To: Cranston City Plan Commission  
From: Doug McLean, AICP, Principal Planner, Administrative Officer  
Date: July 1, 2021  
Re: **Dimensional Variance at 86 Calder Street**

**To allow the expansion of a Motor Vehicle Repair and Service Establishment light in within a front yard setback. The new building addition will be located 35.7 feet from the front property line whereas 40 feet is required in an M-1 zone. [17.20.120- Schedule of Intensity Regulations]**

# SITE PLAN

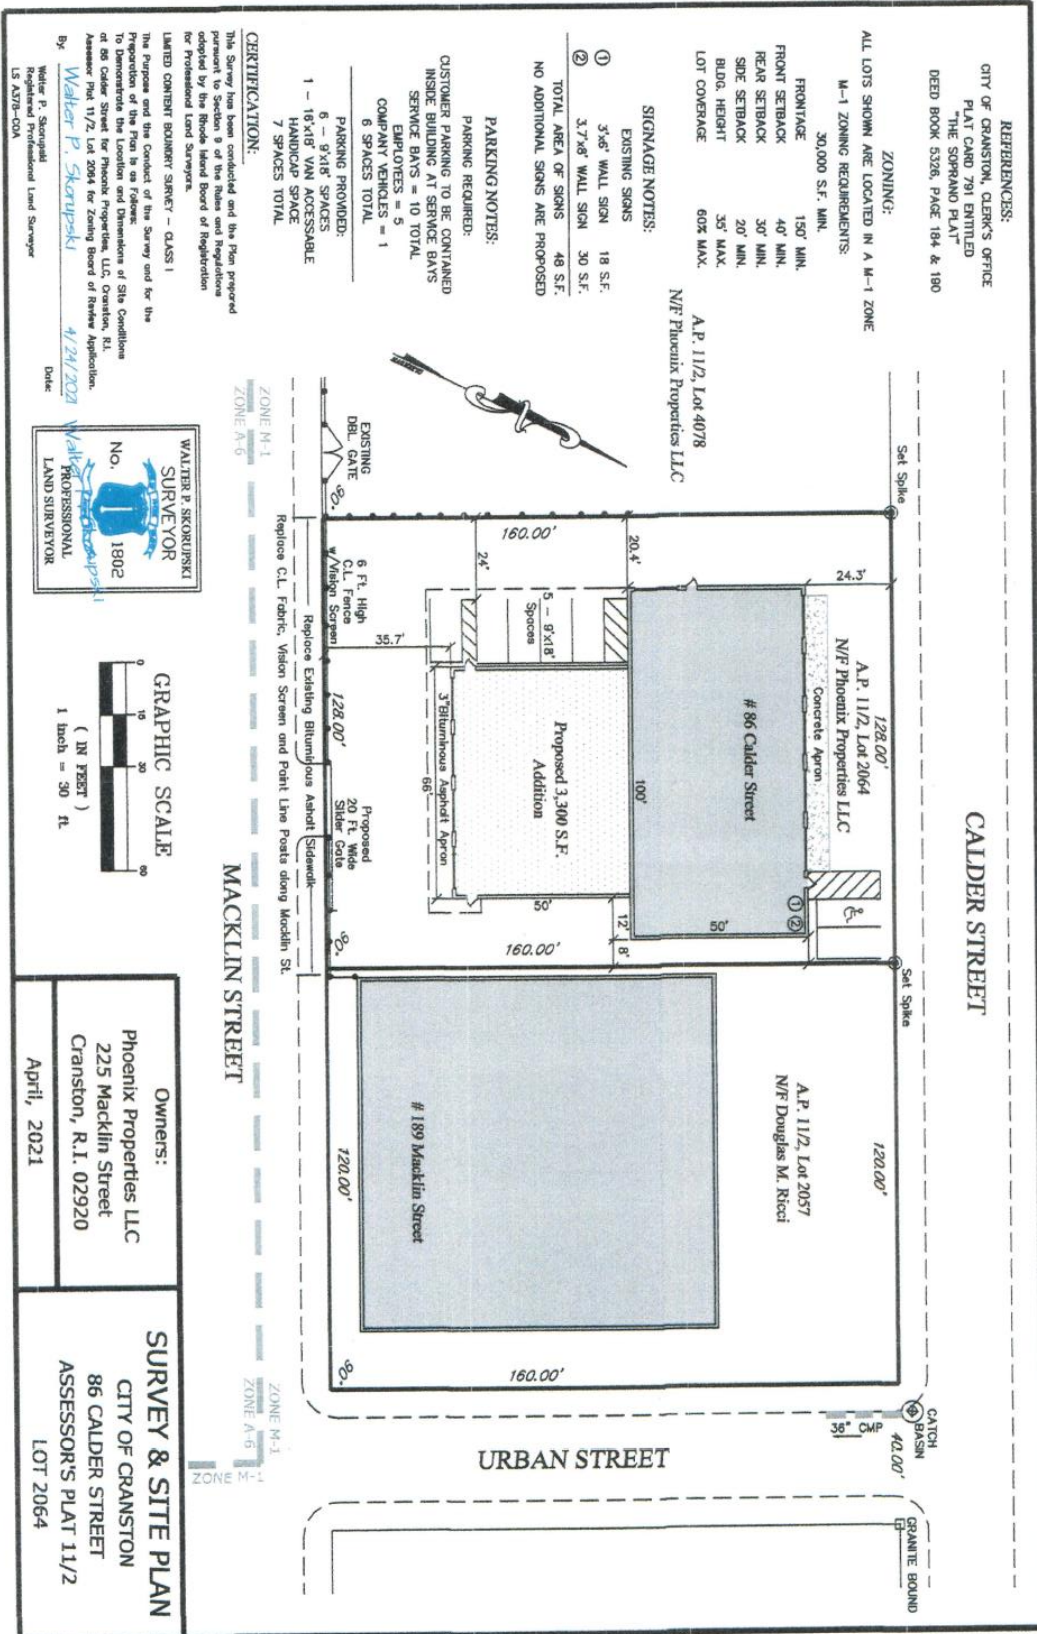
1. The applicant is proposing to add a 3,300 ft<sup>2</sup> to the rear on an existing Motor Vehicle Repair and Service Establishment light operation.
2. The new building addition will be located 35.7 feet from the front property line of the Macklin Street right-of-way whereas 40 feet is required in an M-1 zone.

3. The new addition meets all other dimensional requirements of the zoning code, including side setback, lot coverage, and parking.
4. The property is known as a “through parcel” meaning it abuts 2 separate public right-of-ways on opposite sides of the parcel. Because of this, the Macklin Street side of the property is regulated as a front property line, although it should be noted the front of the building/business operation is oriented toward the Calder Street right-of-way.

5. As a result of the building addition, a new parking layout and interior circulation plan has been provided for the Macklin Street side of the property. There will also be a new access point from Macklin Street as part of this proposal. This will result in “cleaning up” the Macklin side of the property with regard to the current fence and vehicle storage.

6. The relative amount of relief requested is 4.3 feet in comparison to the 40-foot setback standard. Therefore, the applicant is seeking relief for approximately 10% of the length of the required standard.

7. It should be noted that there are single-family dwelling units in a residential zone (A-6) across the street (Macklin Street) from the subject property. While the Motor Vehicle Repair and Service Establishment is allowed to operate at this location, the impact of this proposed variance must be weighed against the likely impacts on the surrounding neighborhood. In this case, it should be noted that the applicant intended to “clean up” the Macklin Street property line by replacing the C.L. Fabric Vision Screen on the existing fence and by removing some of the vehicle storage on this side of the property. These aesthetic improvements are relevant to consider as they serve as a mitigation strategy to potential visual impacts on surrounding properties.

Due to the finding that the application is consistent with the Comprehensive Plan, and due to the finding that the application will not negatively impact the general character of the surrounding neighborhood, staff recommends the Plan Commission provide a **positive recommendation** on this application to the Zoning Board of Review.
